Service Bulletin

UL2 Mechanical Suspension

Air Tank Failures

January 2017

Figure 2

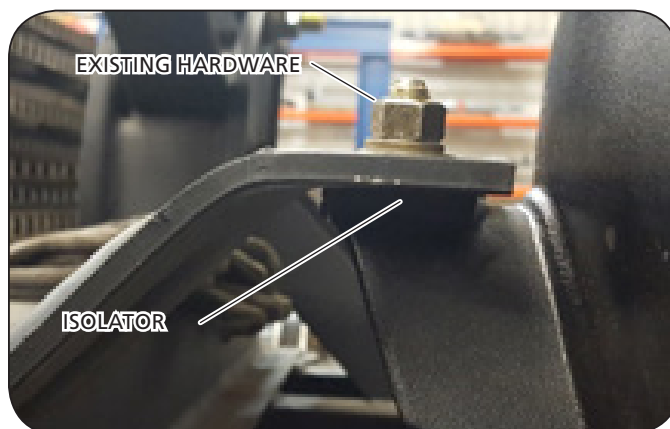
For installation of enhancement kit you must remove existing hardware and isolator pad used to fasten the air tank to the suspension bogie (**Figure 2**). Discard this hardware.
